Date of Application: 4/19/2023

SUBJECT: Preliminary Site Plan and Design review for 40 Residential Units 2306 Fillmore Street.

PROPOSED 39 UNITS
MULTI-FAMILY
DEVELOPMENT FOR:
2306 FILLMORE STREET
HOLLYWOOD FL

- ALL PAVEMENT MARKINGS AND SIGNAGE SHALL CONFORM TO "BROWARD COUNTY TRAFFIC ENGINEERING DIVISION STANDARDS" (BCTED) AND "THE MANUAL ON UNIFORM TRAFFIC CONTROL DEVICES" (MUTC) STANDARDS.

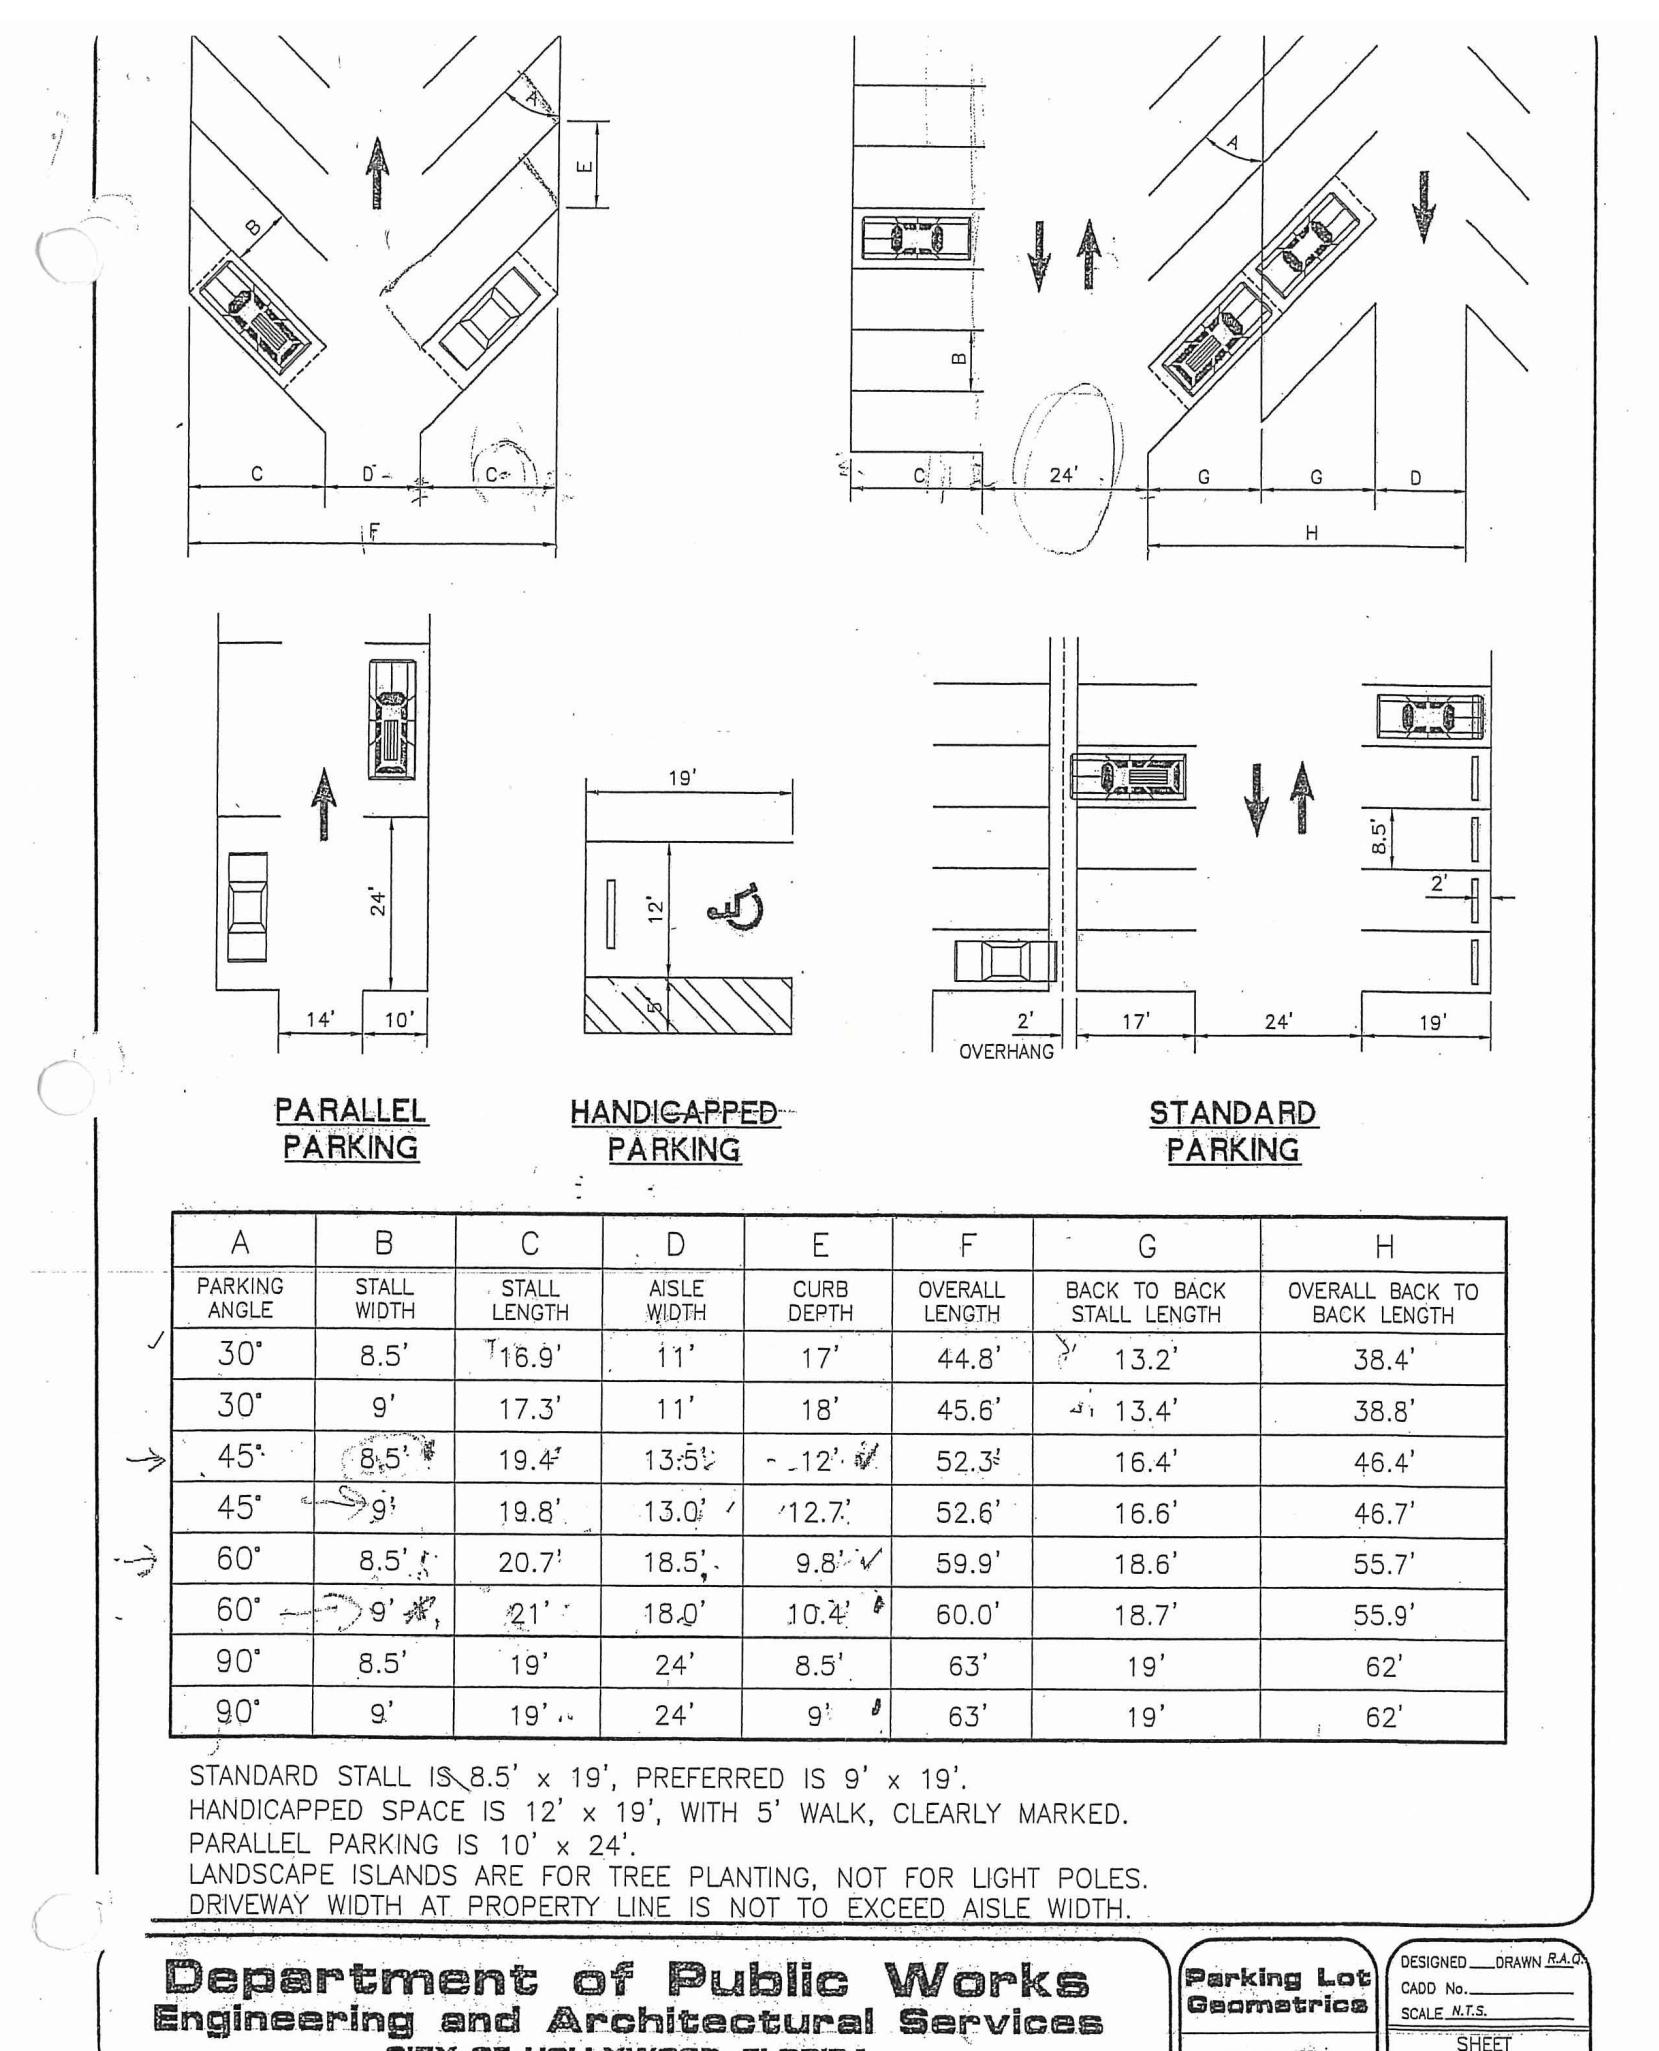
32. Please provide a pavement marking plan that is compliant with Broward County Traffic Engineering and City of Hollywood Standards. Provide any and all applicable standard sheets in the plan. (i.e. stop bars, do not enter signs, directional arrows, wrong way signs, parking stall stripping, ADA pavement markings etc.).

Response:Refer to sheet C-101 for Pavement marking & signage sheet.

SCALE: 1" = 10'
DATE: 04/18/23
DRAWING TITLE:
PAVING, GRADING,
DRAINAGE PLANS
SHEET NO.
C-200

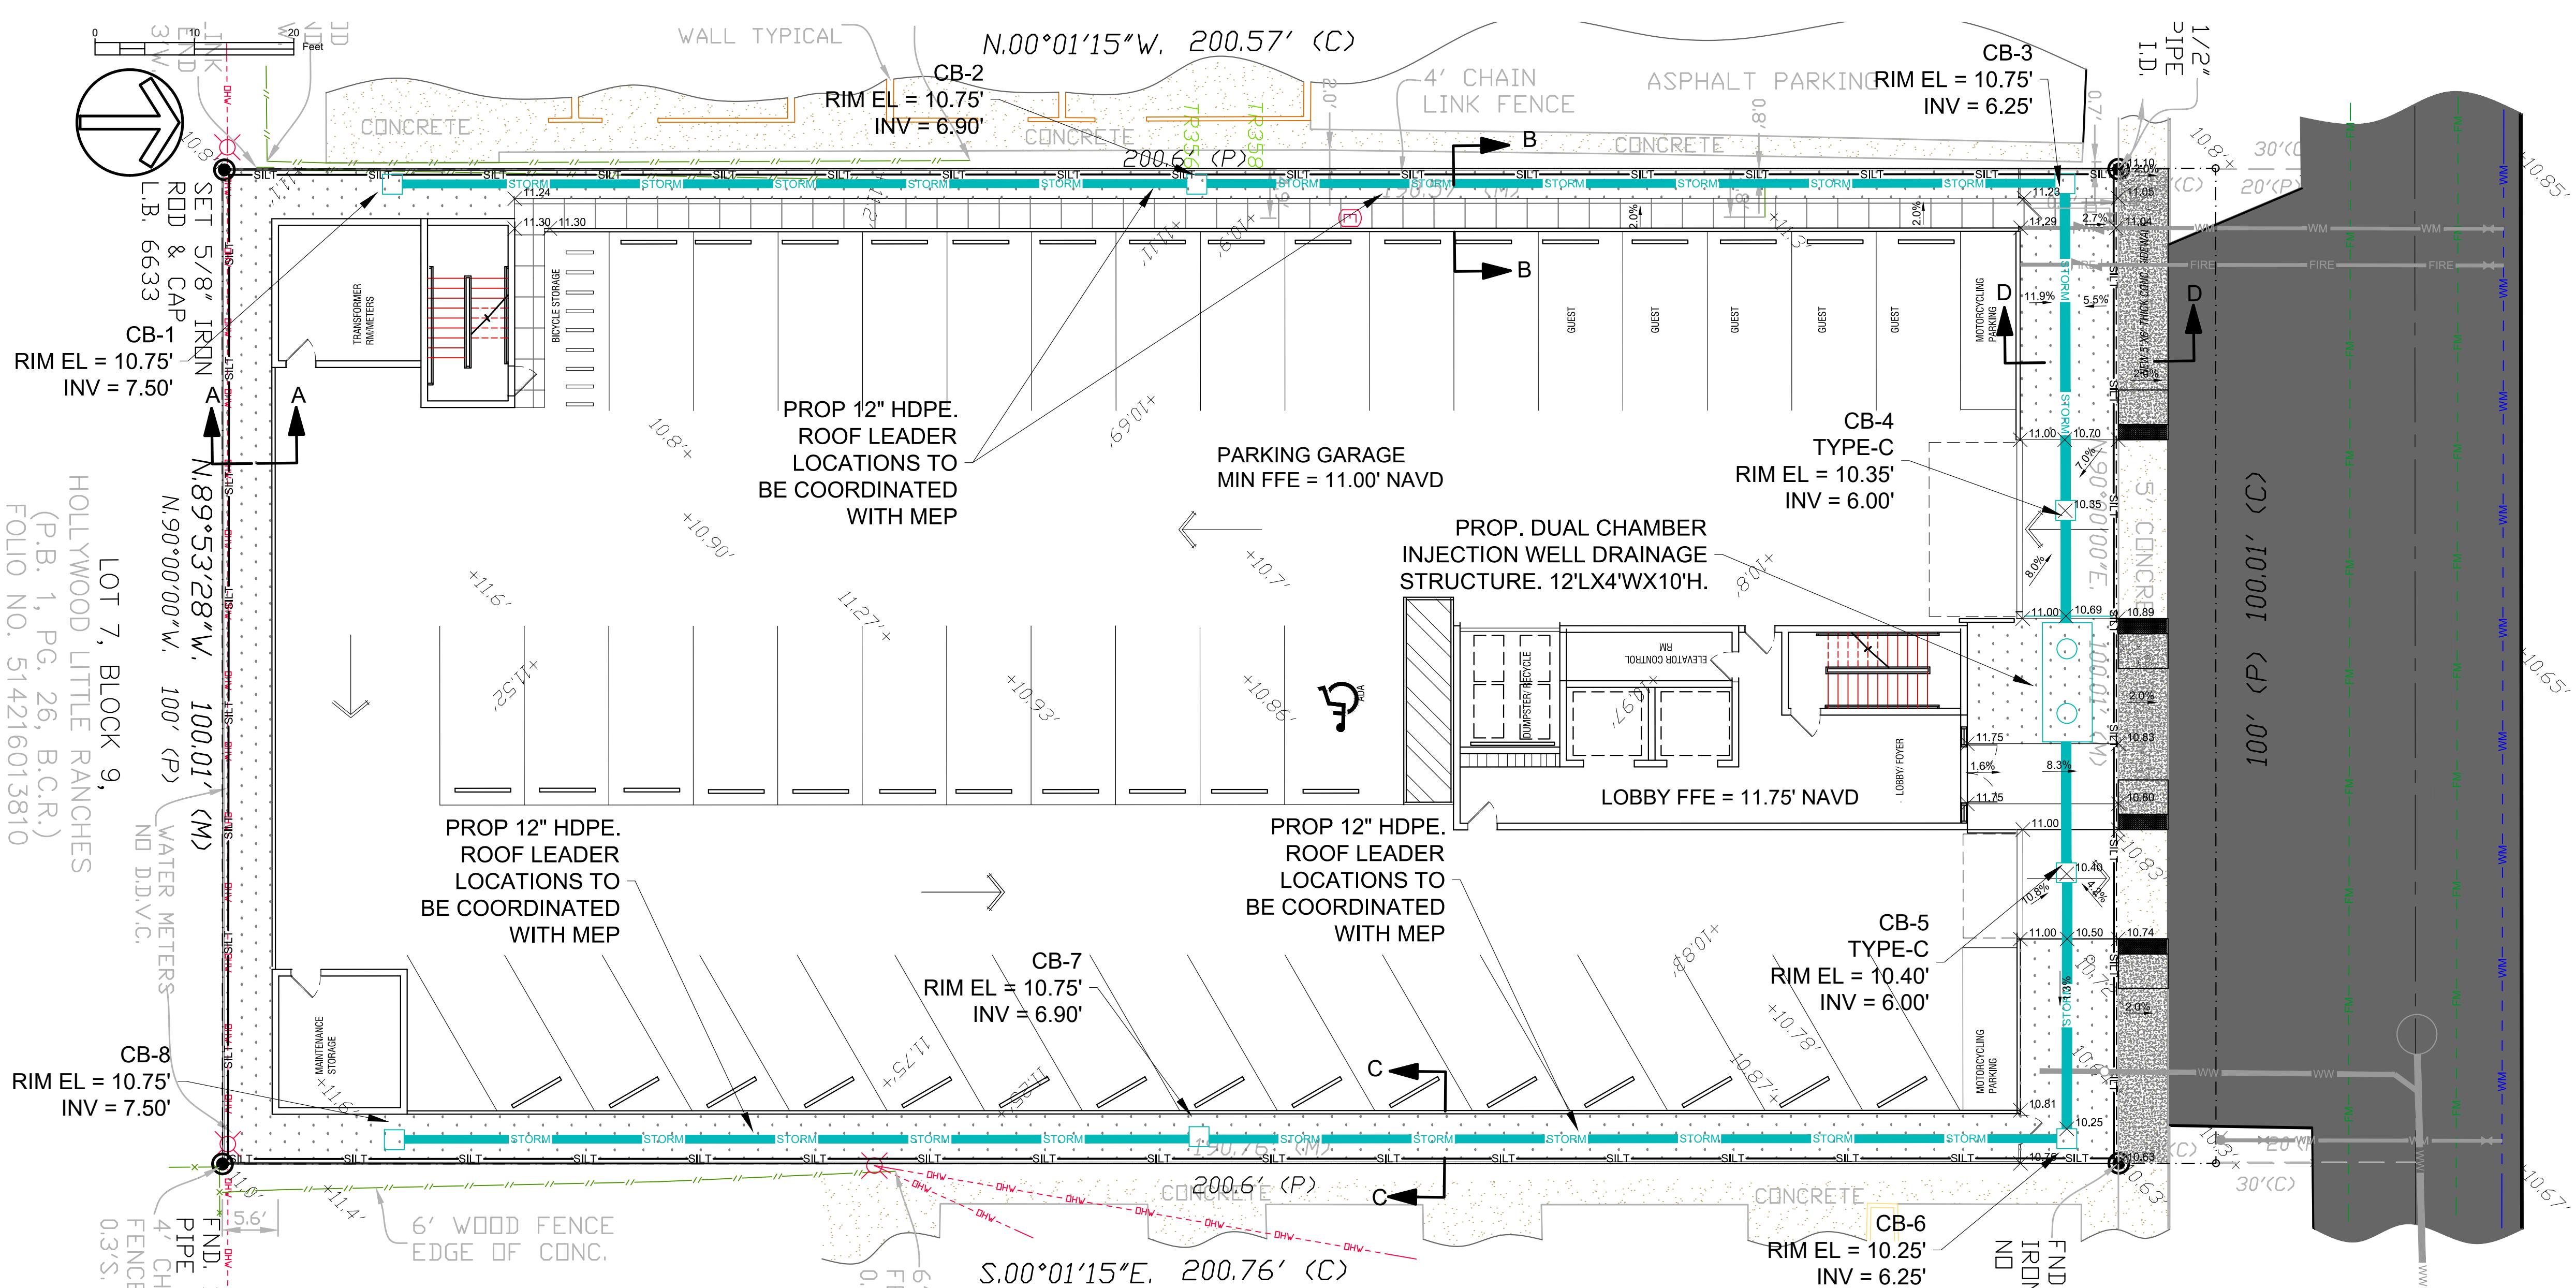
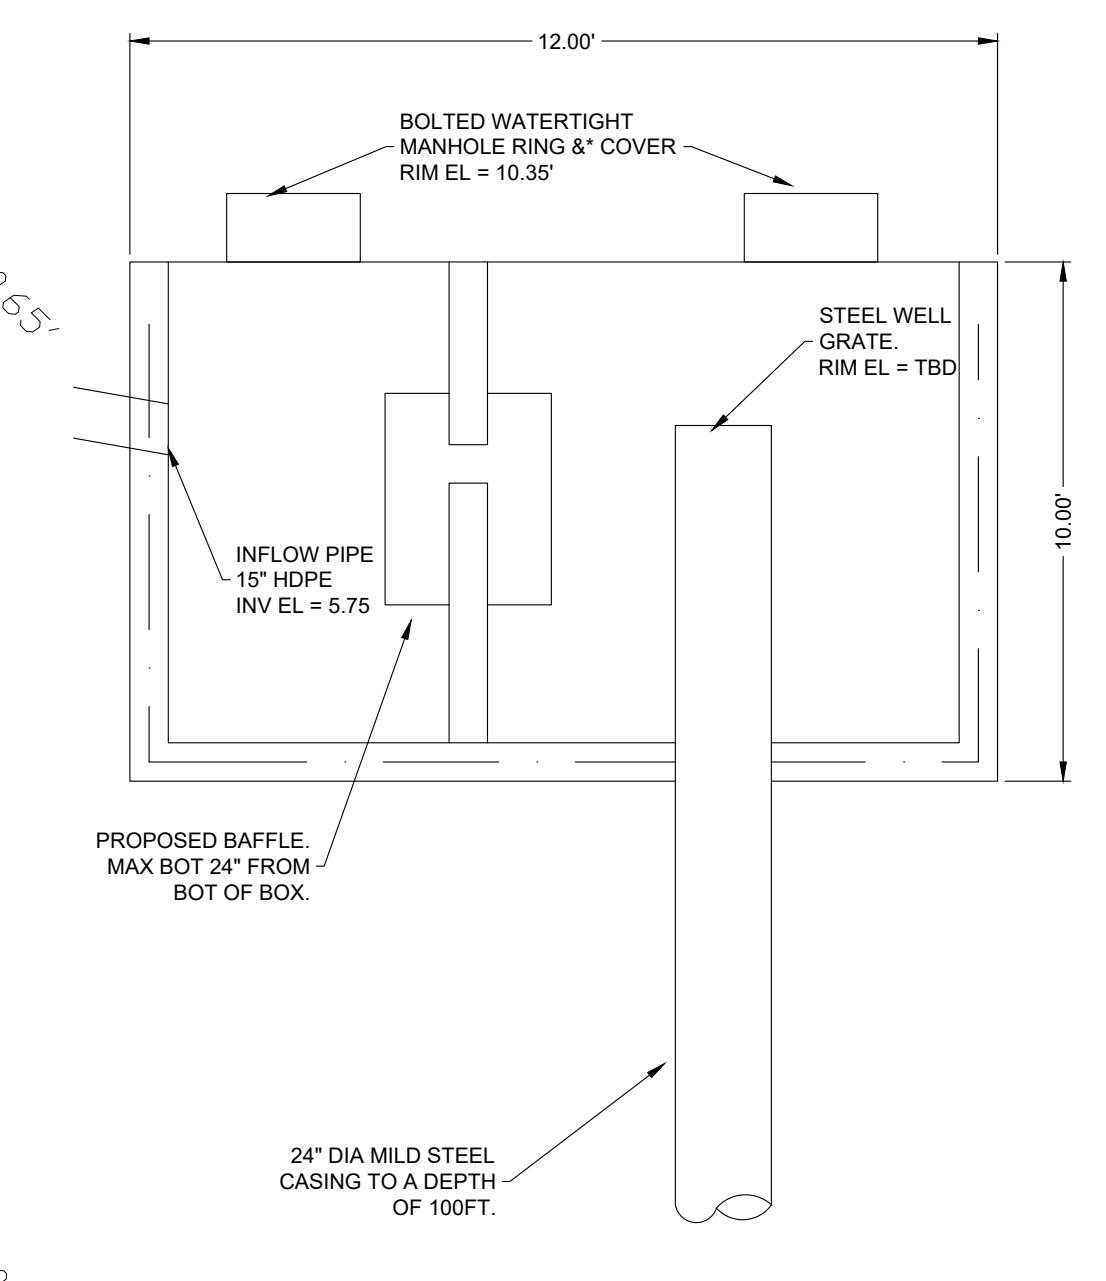
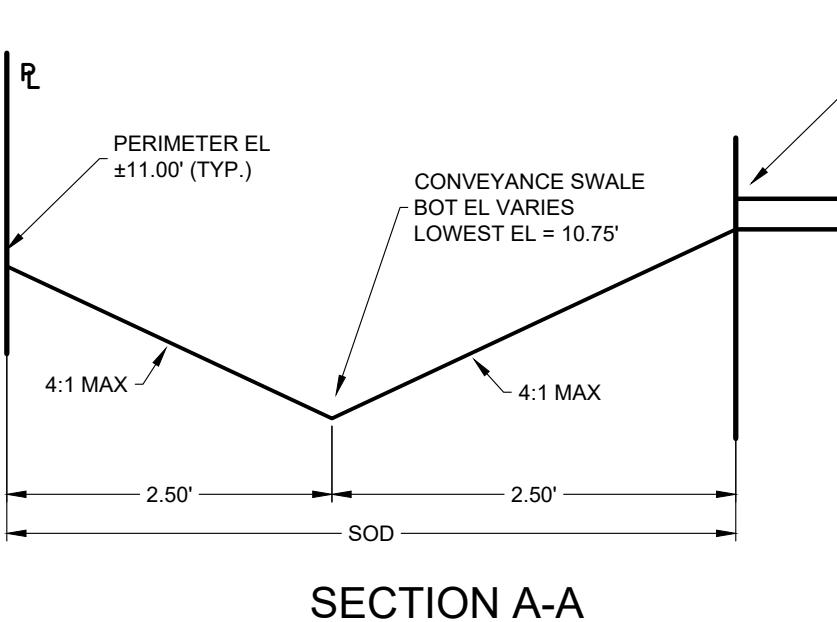
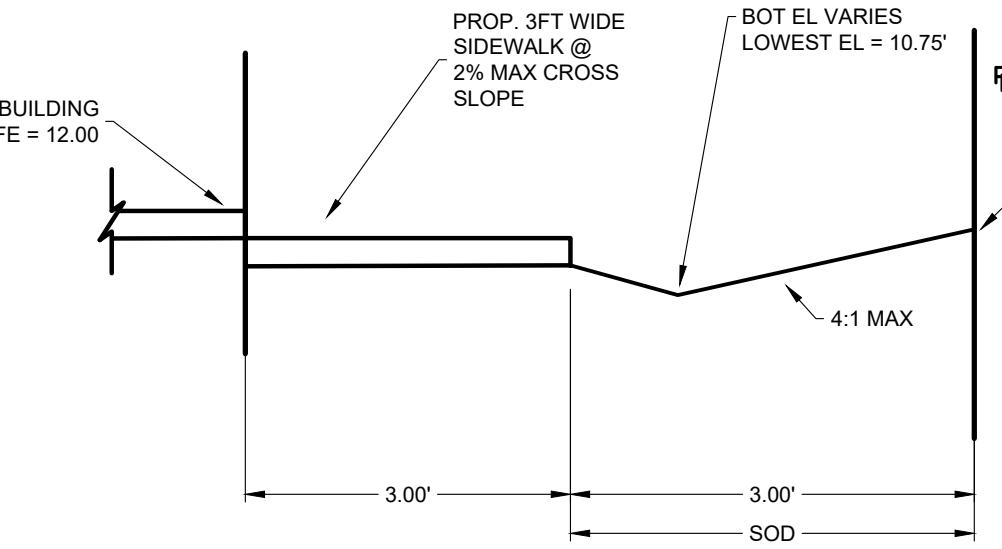
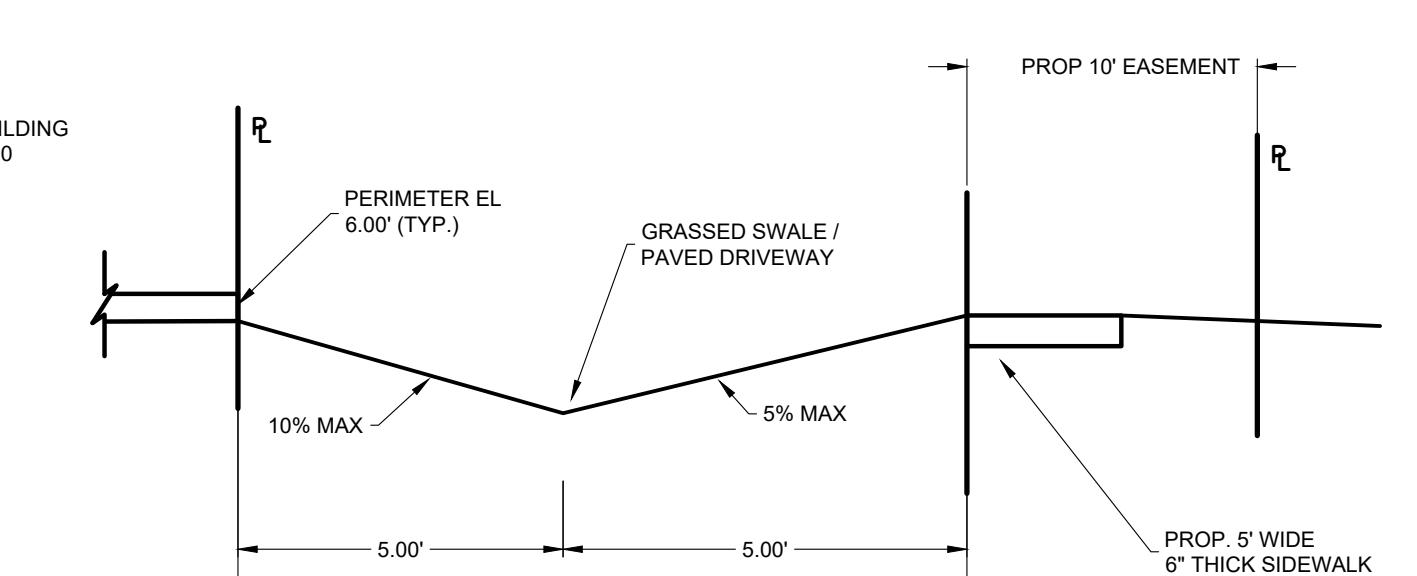
36. Applicant will need to restore the swale area of the ROW. Please provide a plan showing the removal of the existing apron and restoration of the swale from property line to edge of pavement in the ROW. The proposed aprons will need to extend to the edge of pavement in the ROW on Fillmore and the areas adjacent to them are to be restored with sod.

6. Provide perimeter cross sections across all property limits including dimension, transition areas with 6" swales, slopes 4:1 (3:1 max) and meeting adjacent property grades.

7. Provide details for proposed dual chamber injection wells and catch basins including rim and invert elevations.

Response: Concrete apron and roadside swale to be restored. Refer to sheet C-200.

Response: Perimeter cross-sections are provided.

Response: Catch basin and injection well details are provided.
